SERVICE BULLETIN CHANGE NOTICE

S.B. No. A320-21-1018

TITLE: AIR CONDITIONING - DELETE BILGE AIR INTAKE

MODEL: All models listed in S.B.

Deletion of the Inlet Funnel
Figure 1

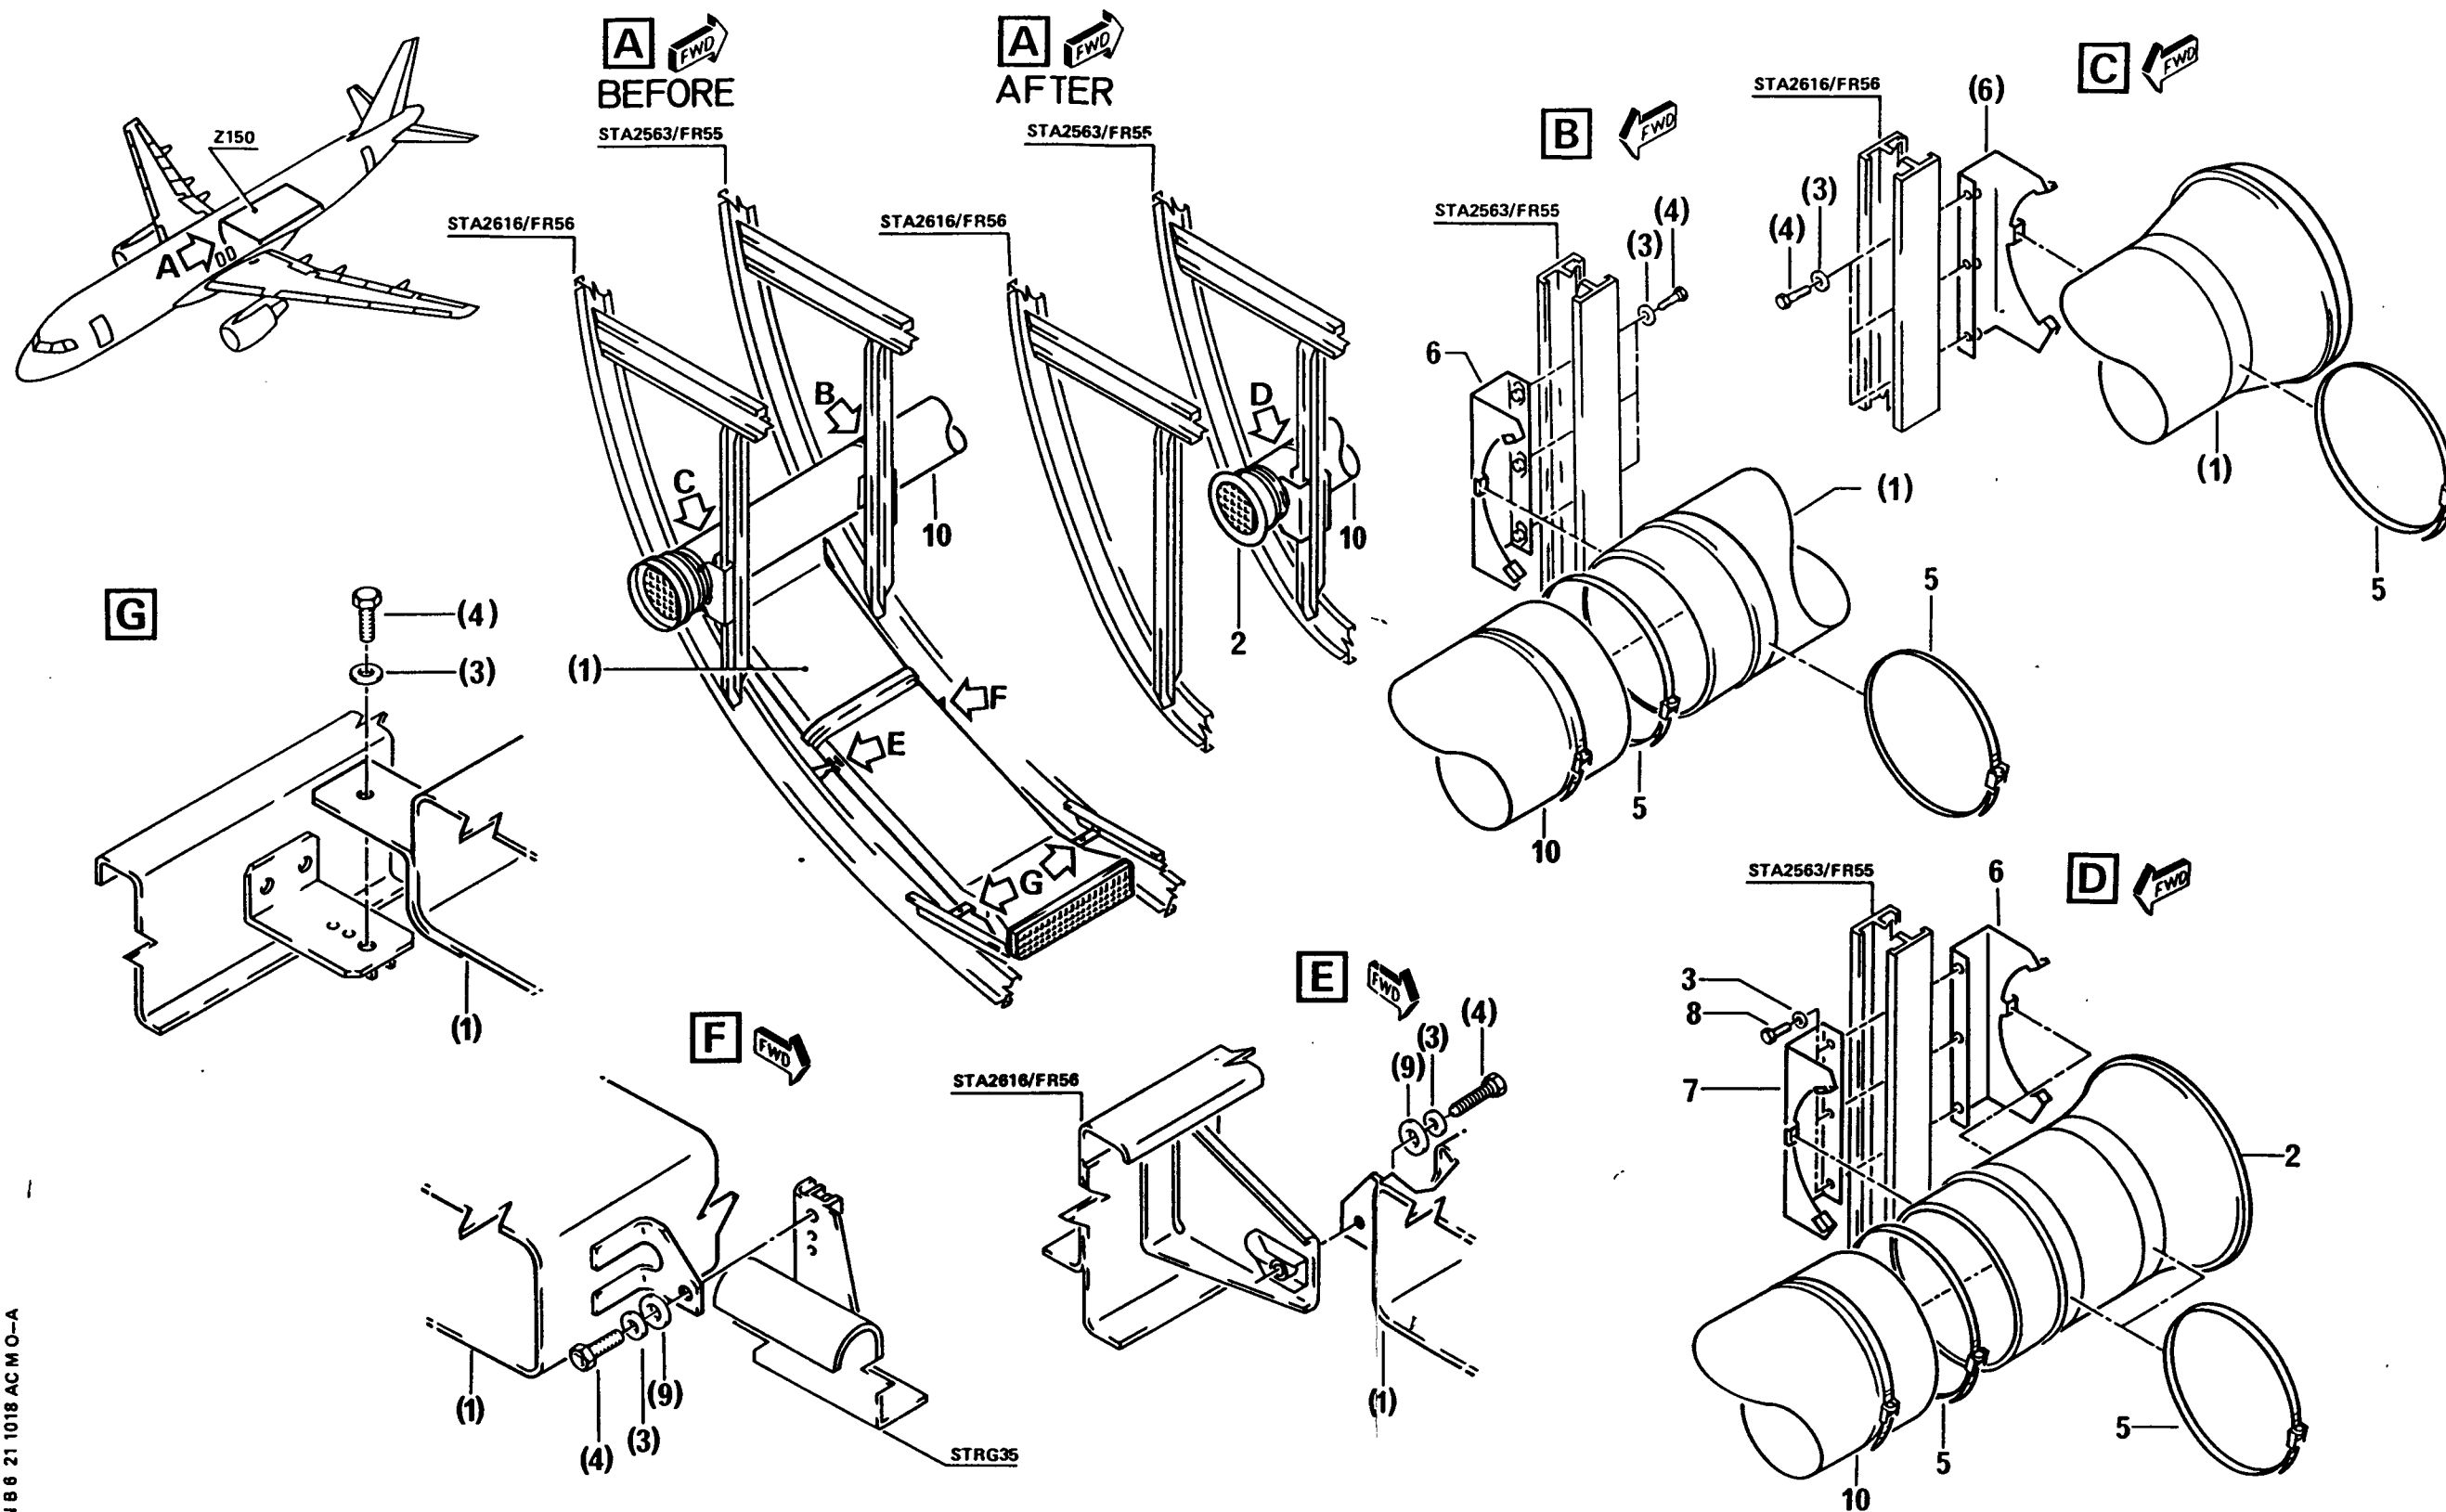
Flight test results show extreme low bilge temperature resulting into low ventilation inlet temperature. To avoid low inlet temperature resulting in a too low cargo compartment temperature, this Service Bulletin proposes to delete the bilge air intake.

(1) Removal of the Inlet Funnel, item (1)

(a) Remove from the area between FR55 and FR56:

- 4 screws item (4) (discard),
- 4 washers item (3) (discard),
- 2 washers item (9) (discard).

(d) Remove the inlet funnel, item (1) (discard).

(2) Removal of the Brackets, item 6

- 3 screws item (4) (discard),
 - 3 washers item (3) (discard),
 - 1 bracket item (6) (discard),
- as shown in detail C.

(b) Remove from the support strut between FR55 and the floor structure:

- 3 screws item (4) (discard),
 - 3 washers item 3 (retain),
 - 1 bracket item 6 (retain),
- as shown in detail B.

(3) Installation of the Brackets, items 6 and 7

- 1 retained bracket, item 6,
 - 1 bracket D2127349720000, item 7,
 - 3 retained washers, item 3,
 - 3 screws NAS1096-3-8, item 8,
- as shown in detail D.

(4) Install the inlet funnel D212725370000, item 2, on the tube, item 10, with the retained clamp, item 5.

(5) Install the inlet funnel, item 2, on the brackets, items 6 and 7, with the 2 retained clamps, item 5.
